ROANOKE MUNICIPAL BUILDING ANNEX
ROANOKE VIRGINIA
ARCHITECTURAL
SOUTH AND EAST ELEVATIONS

SCALE AS SHOWN | COMM. NO. 3260
DATE 1 JUNE 1968 | SHEET A-7

SOUTH ELEVATION

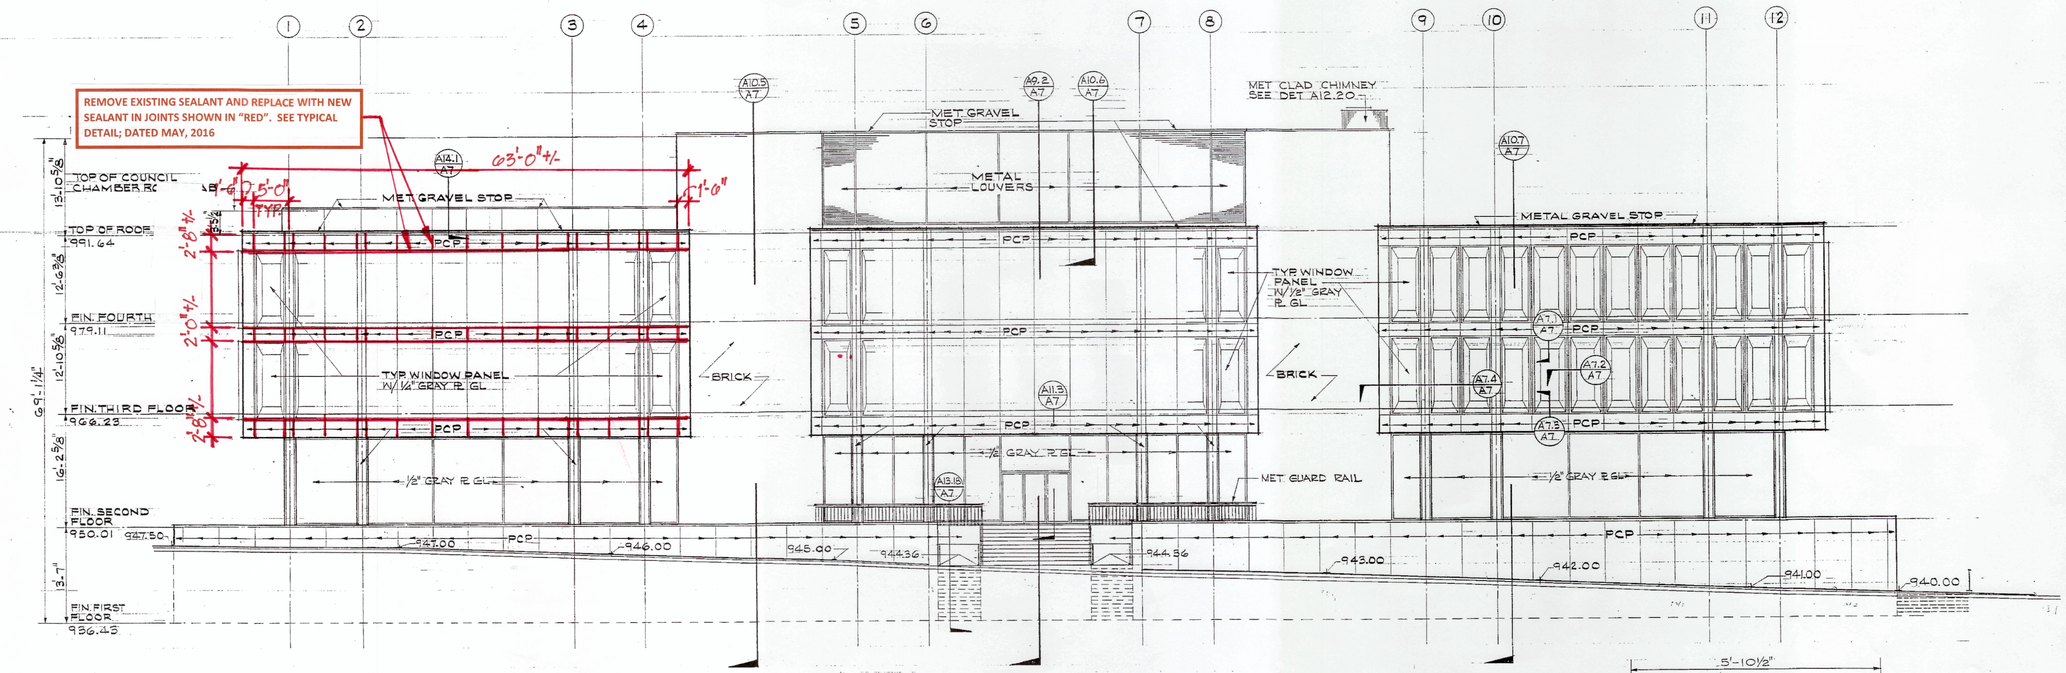
REMOVE EXISTING SEALANT AND REPLACE WITH NEW SEALANT IN JOINTS SHOWN IN "RED". SEE TYPICAL DETAIL; DATED MAY, 2016

EAST ELEVATION

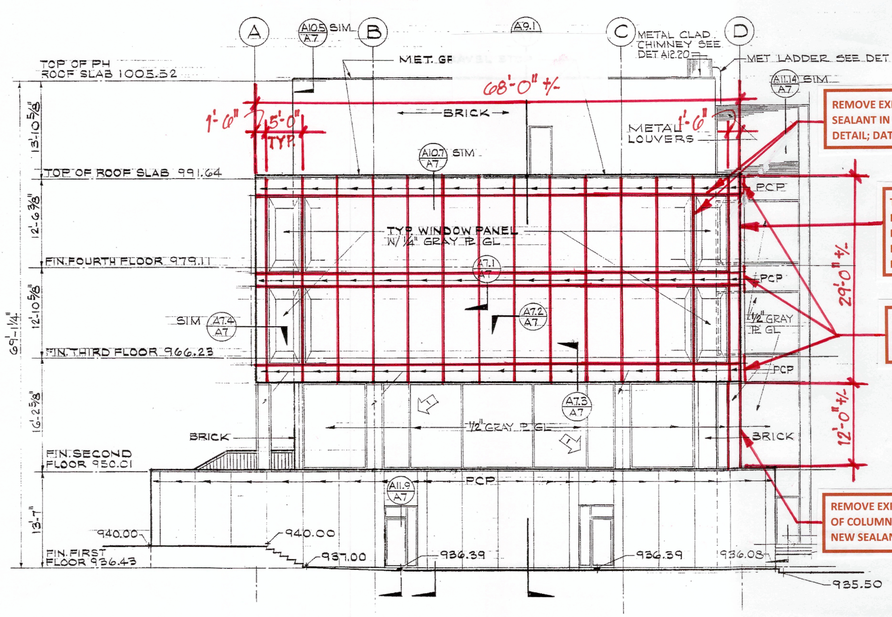
REMOVE EXISTING SEALANT AND REPLACE WITH NEW SEALANT IN JOINTS SHOWN IN "RED". SEE TYPICAL DETAIL; DATED MAY, 2016

TWO (2) VERTICAL JOINTS @ 29'-0" EACH AND FOUR (4) HORIZONTAL JOINTS @ 3'-0"+/- EACH LOCATED IN AREA WHERE EXISTING AGGREGATE-FACED PRECAST CONCRETE ABUTS EXISTING BRICK

THREE (3) VERTICAL JOINTS @ 4'-0"+/- EACH LOCATED WHERE EXISTING PRECAST SPANDREL PANEL ABUTS EXISTING BRICK

PLAN SECTION

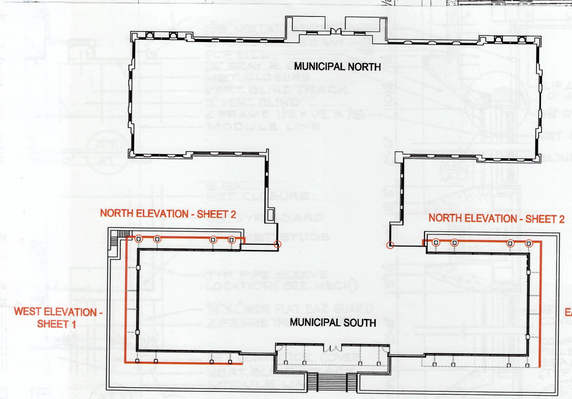
REMOVE EXISTING SEALANT AT FOUR (4) CORNERS OF COLUMN SHOWN IN "RED" AND REPLACE WITH NEW SEALANT. SEE TYPICAL DETAIL; DATED MAY, 2016
